SUBJECT: **CONSIDERATION OF A CONDITIONAL USE PERMIT (CUP12-00017) FOR THE CONSTRUCTION AND OPERATION OF A SMALL SOLAR FACILITY ON VACANT LAND IMMEDIATELY SOUTH OF THE SAN LUIS REY WASTEWATER TREATMENT PLANT LOCATED AT 3950 NORTH RIVER ROAD – APPLICANT: CITY OF OCEANSIDE WATER UTILITIES DEPARTMENT**

**Final Initial Study/
Negative Declaration
San Luis Rey Wastewater
Treatment Plant Solar Project
Oceanside, California**

Subject: Comments on the Initial Study for the San Luis Rey Wastewater Treatment Plant Solar Project, City of Oceanside, San Diego County (SCH# 2012061073)

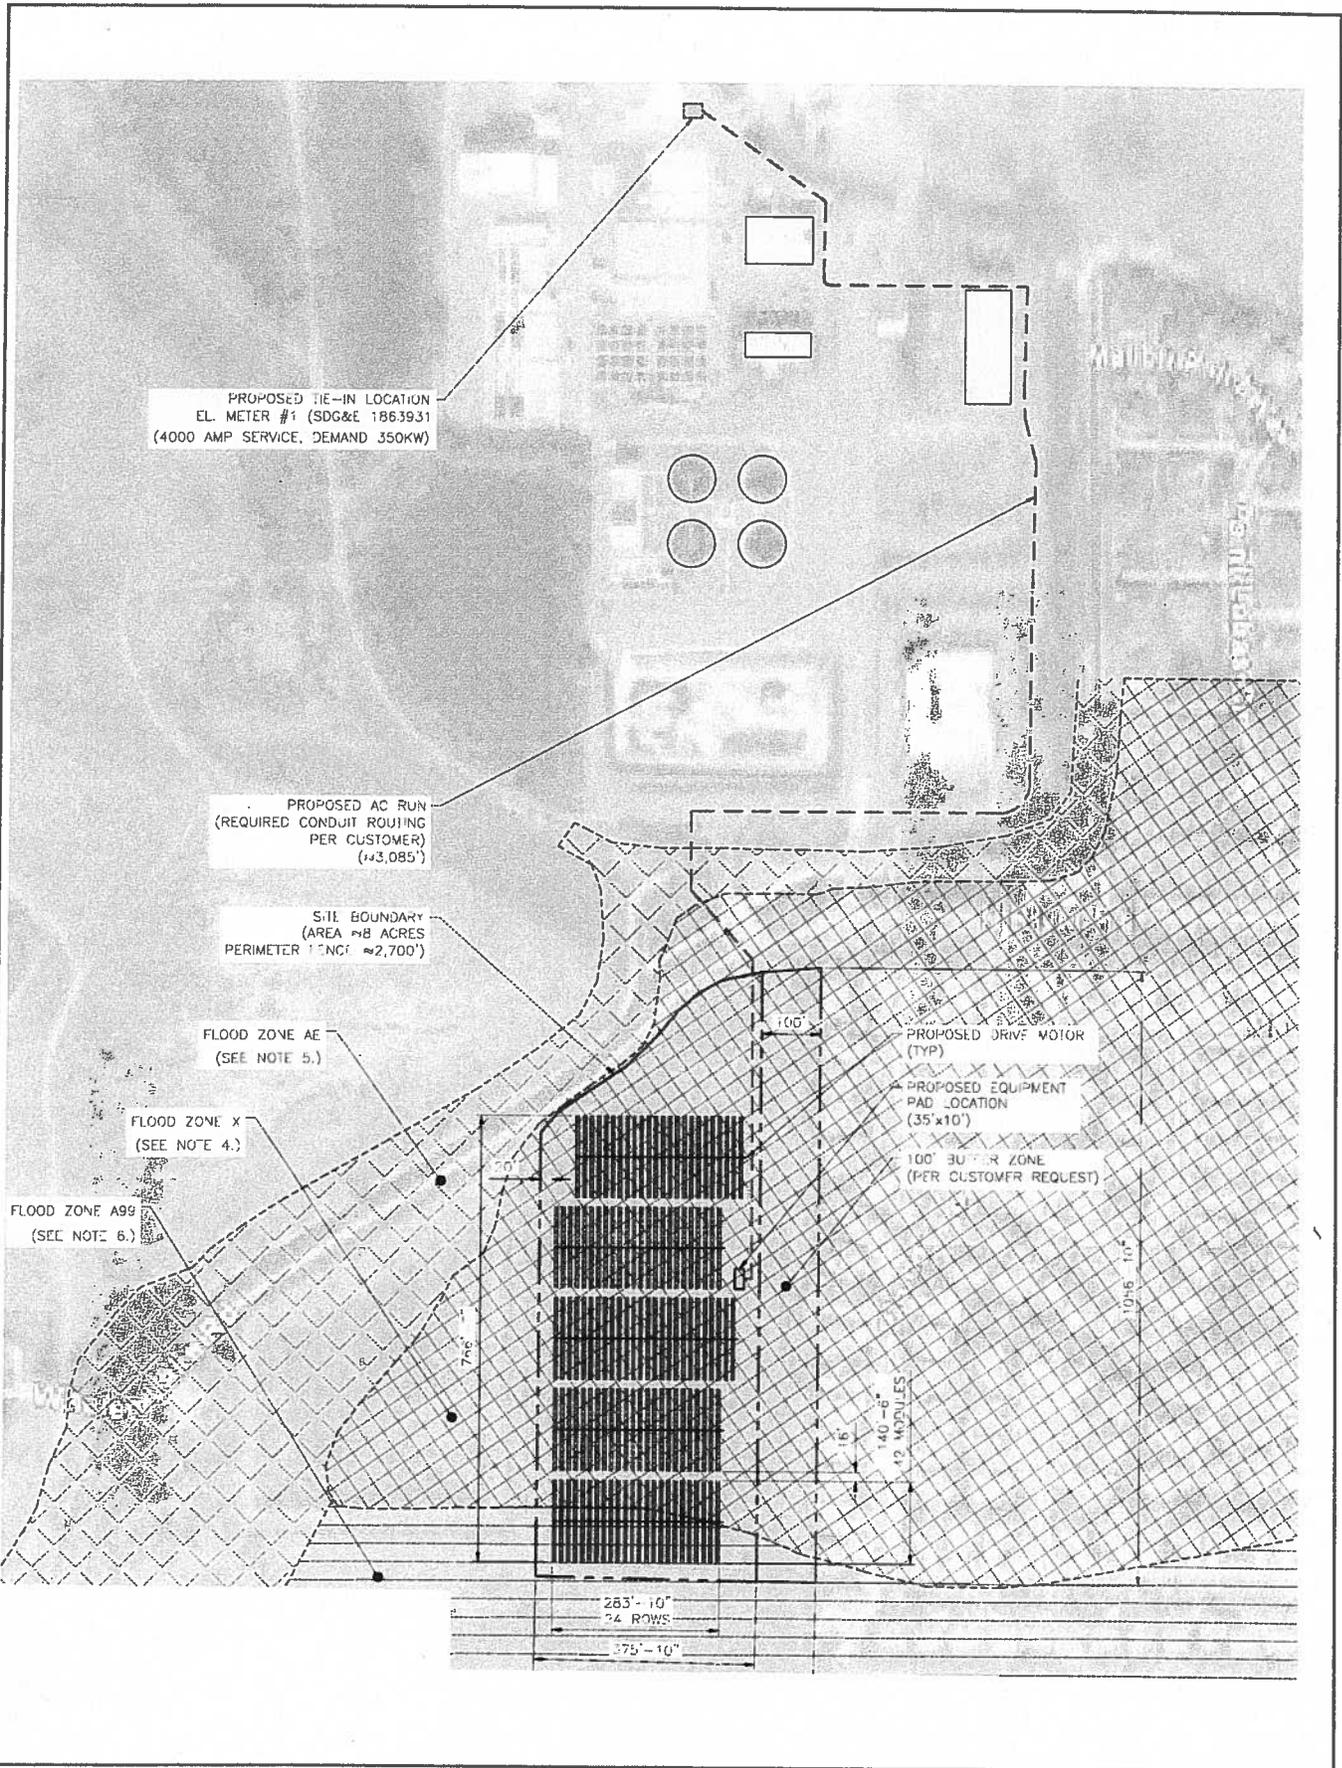
DFG recommends that the final IS/ND (a) clarify verbally and graphically the exact two alternate locations and alignments of the transmission line, (b) separately analyze impacts to biological resources for each of the two transmission line alignments and (c) include proposed mitigation measures to mitigate potential impacts to levels less than significant.

The City has evaluated the "Alternative Transmission Line" from an engineering and cost perspective and has determined that this alternative does not provide any additional benefit. Therefore, the "Alternative Transmission Line" is no longer under consideration, and any reference to this alternative has been removed from the IS (e.g. IS Figure 1).

Please refer to response to comment 1-12. The potential impact of the proposed transmission line has been evaluated in the IS. As shown on IS Figures 1 and 2, the proposed transmission line will be located within an existing paved access road associated with the existing Wastewater Treatment Plant, or within the immediately adjacent landscaped areas. IS Item #8 Project Description, has been revised to clearly indicate this.

Typical Fixed-tilt Tracking Solar Panel Rows
FIGURE 3

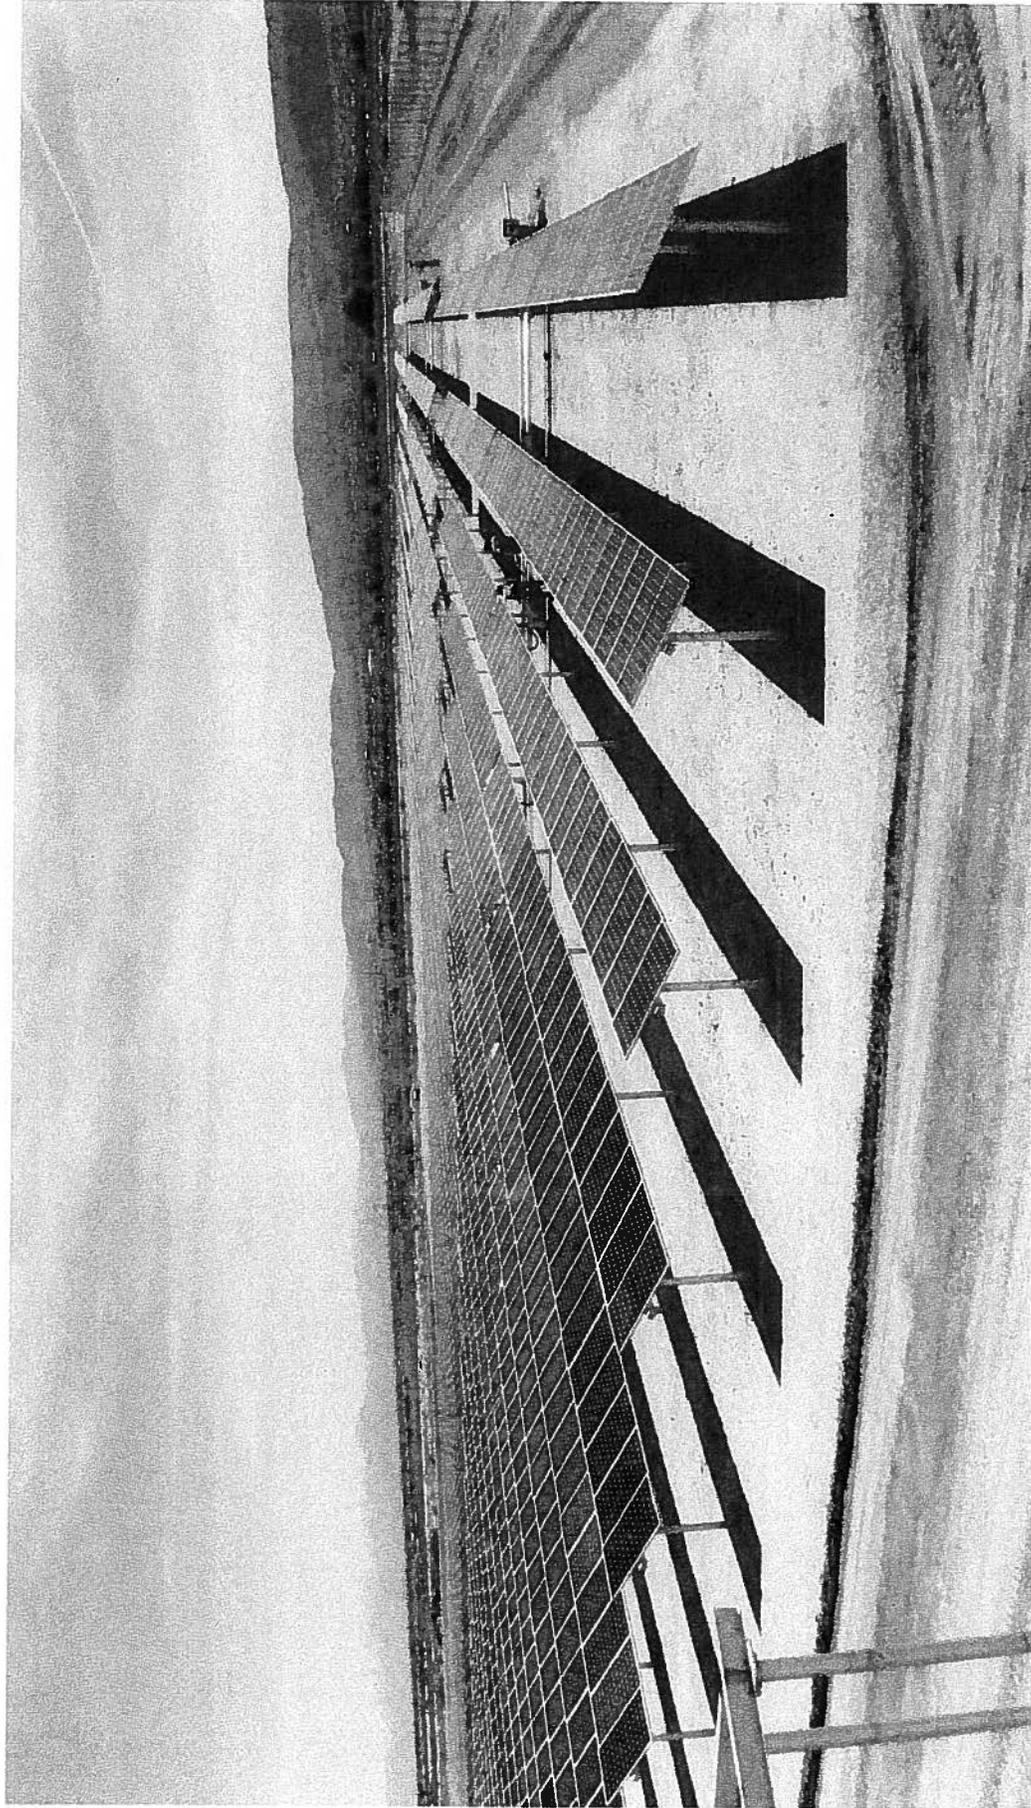
Solar Technology. While the IS characterizes the Project as "...a solar array field containing 3,168 high efficiency (327 watt) solar panel modules...", the IS is unclear as to the exact solar technology that is being proposed. The only reference to photovoltaic technologies is on Figure 3 of the IS. Alternative solar technologies (e.g., parabolic trough) often have a suite of biological considerations unique to the particular technology. The type of technology utilized influences DFG's scope of comments. Therefore, DFG recommends the Lead Agency identify the proposed technology in the IS.

The proposed project will employ a photovoltaic (PV) mounted on a tracking system. Figure 3 of the IS provides a representative photograph of the characteristics of the proposed PV technology system. Item #8 Project Description, of the IS has been revised to clearly indicate that PV panels are proposed.
